VILLAGE OF LINCOLNSHIRE

AGENDA COMMITTEE OF THE WHOLE Village Hall – Board Room Monday, January 13, 2020 Following Regular Village Board

Reviewing Body:	Committee of the Whole
Meeting Date:	January 13, 2020
Subject:	Amerimark Interactive Building Wall Sign - Tri-State Planned Unit Development Comprehensive Sign Package
Property Address:	200 Tri-State International
Petitioner:	Bradford Allen Realty Services
Action Requested:	Public Hearing regarding a Major Amendment to a Special Use for the Tri-State Planned Unit Development (Ordinance No. 03-1829-06) to Revise a Comprehensive Sign Package for Tri-State International
Prepared By:	Tonya Zozulya – Planning & Development Manager
Staff Recommendation:	A Public Hearing and Consideration of the Amended Ordinance and Placement on the January 27, 2020, Regular Village Board Consent Agenda for Approval
Meeting History:	Committee of the Whole – November 25, 2019 Architectural Review Board – December 16, 2019
Tentative Meeting Schedule:	Regular Village Board – January 27, 2020
Reports and Documents Attached:	<ol style="list-style-type: none"> 1) Location Map 2) Petitioner’s Presentation Packet, Submitted by Bradford Allen Realty Services, w

SHEET NO.:
C3.01

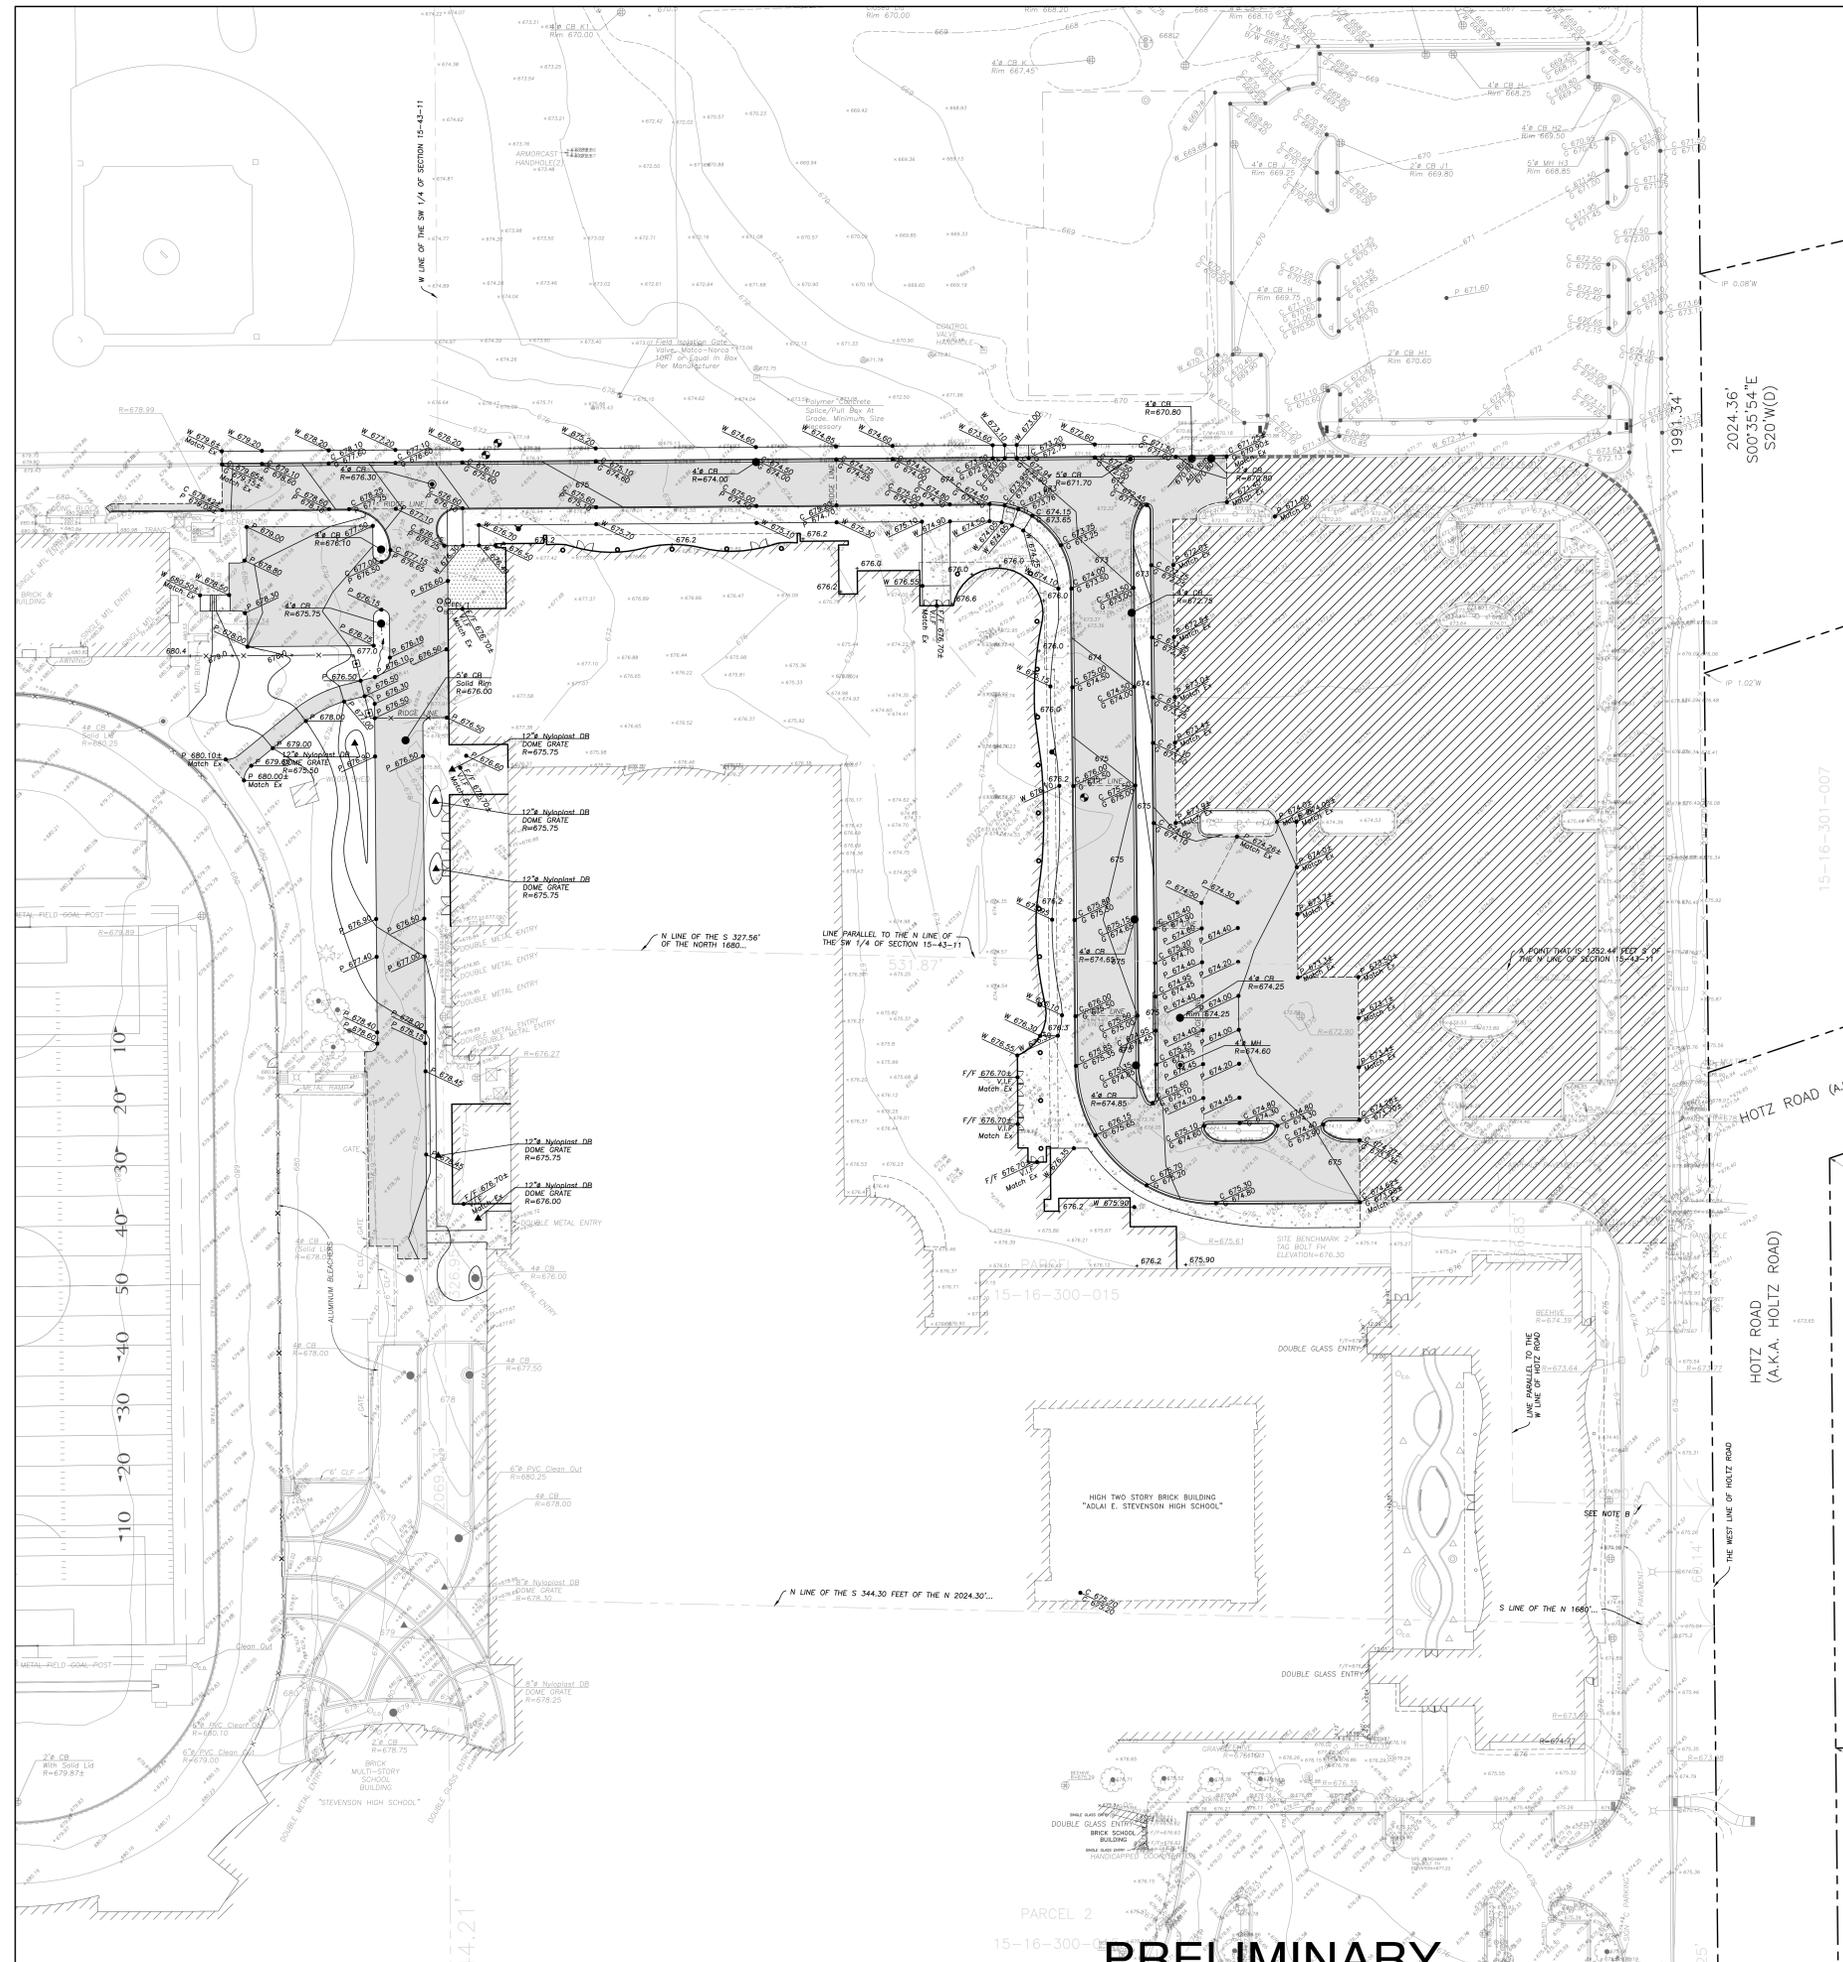
3. Traffic Study/Parking Study will be reviewed in greater detail during DRT process but it should include what offsite improvements could be implemented to not degrade Level of Service on IL 22 during peak hours with the added school traffic. If the degradation in the level of service is due to the increase on IL 22, then that should be clearly shown with the traffic data breakdown.

The increase in delays at the IL 22 signal is due to a combination of additional school traffic and regional traffic growth over the next 8 years (2019 to 2027). The real reason for the degradation of the LOS is due to the existing delays being close to the limit of the LOS criteria than due to traffic increases. The LOS C starts at 20.0 seconds of delay and LOS D starts at 35.0 seconds. Morning delays require an increase of 2.1 seconds to change from LOS C to D. The afternoon delays only have to increase by 0.7 seconds to go from LOS B to C. The actual increase in delay of the next 8 years is 4.3 seconds/vehicle in the morning and 3.0 seconds/vehicle in the afternoon.
